William States Lee III Nuclear Station

COL Application

Technical Specifications

PLANT SPECIFIC TECHNICAL SPECIFICATIONS (PSTS)

Figure 4.1-1

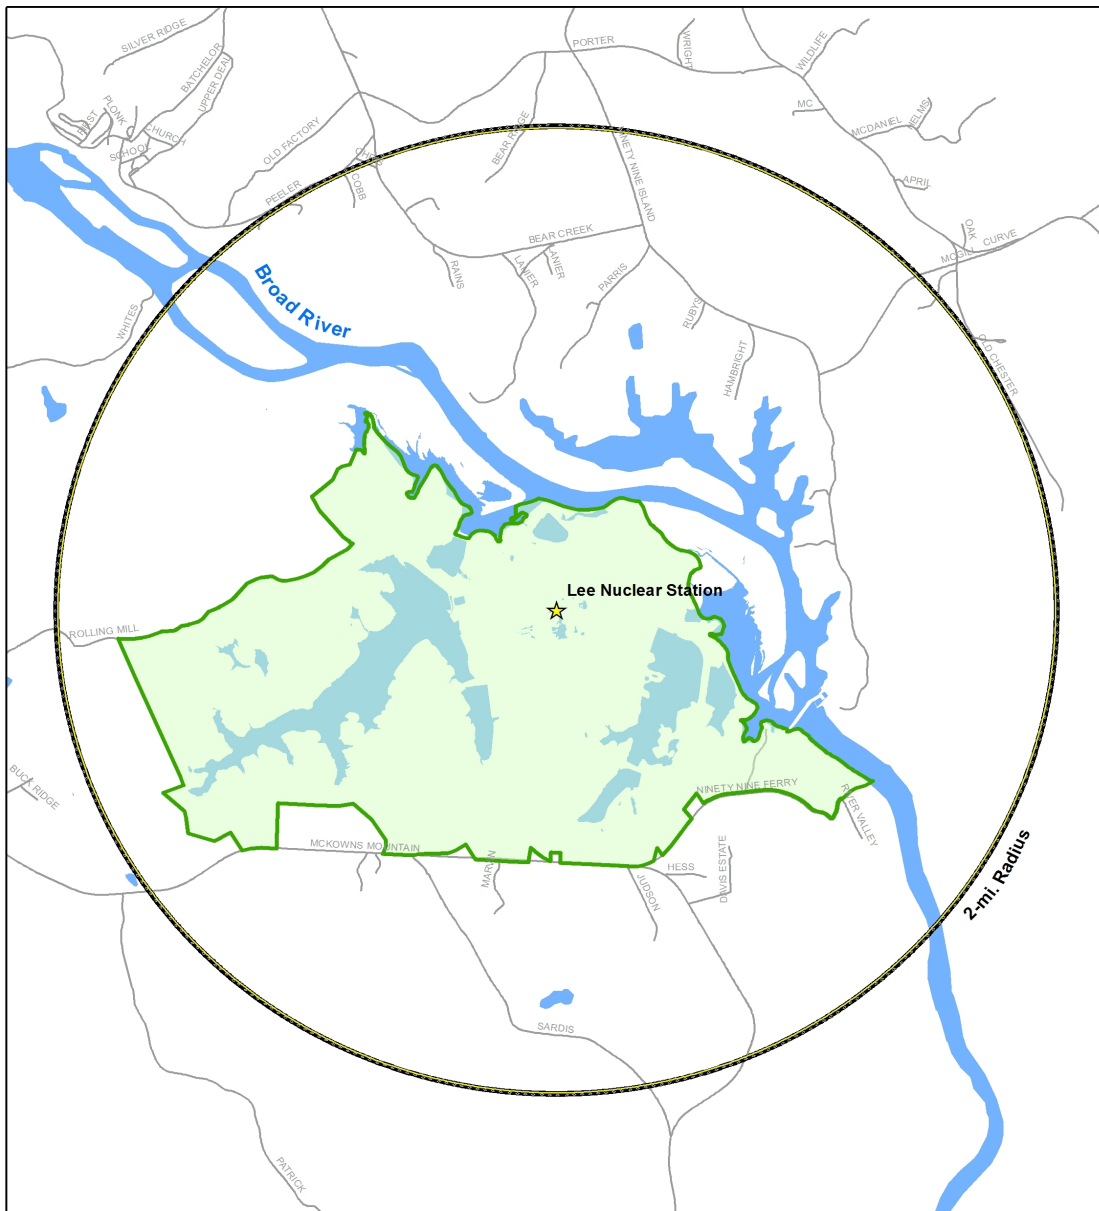
- GTS 4.1.1 The bracketed information in the GTS reads:
[This information will be provided by the combined license applicant.]
Replace the bracketed information in the GTS with the following:
The Site Boundary is shown in Figure 4.1-1. The Exclusion Area Boundary is shown in Figure 4.1-2.
Justification:
Bracketed information is replaced to establish Site Boundary and Exclusion Area Boundary for Lee Nuclear Station consistent with the descriptions identified in FSAR Sections 2.1.1.2.

- GTS 4.1.2 The bracketed information in the GTS reads:
[This information will be provided by the combined license applicant.]
Replace the bracketed information in the GTS with the following:
The LPZ is defined by the 2 mile radius from the site center point as shown in Figure 4.1-1.
Justification:
Bracketed information is replaced to establish the LPZ for Lee Nuclear Station consistent with the descriptions identified in FSAR Section 2.1.3.4.
